2010 SECTION III, DIVISION 2

CC-2300 MATERIAL FOR REINFORCING SYSTEMS**CC-2310 INTRODUCTION**

FIG. VIII-1530-1 COMPLETE JOINT PENETRATION GROOVE

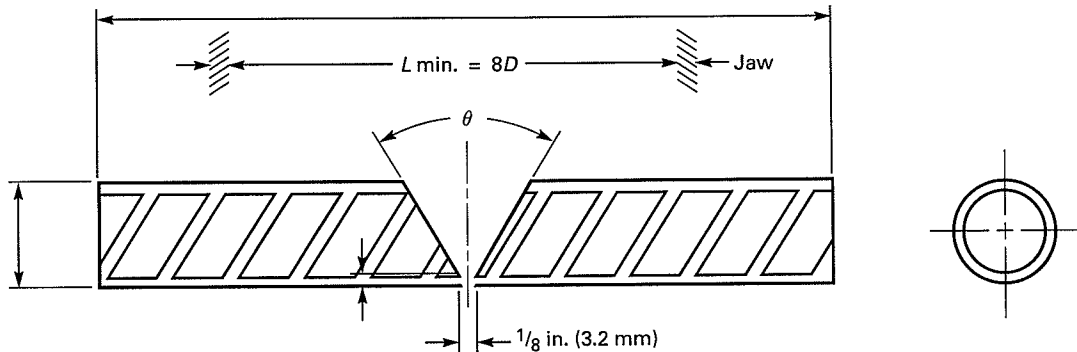
(a) *Full-Section Tension Test.* The tensile test results shall comply with the strength requirements of Table CC-4334-1 for the appropriate grade of reinforcing bar. CC-4333-1

FIG. D-1230-1 MEASUREMENTS OF LOCAL DIMENSIONS PER F-1230

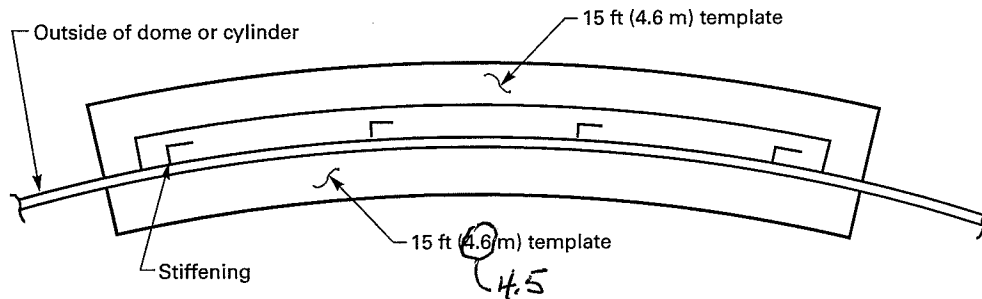
4.5
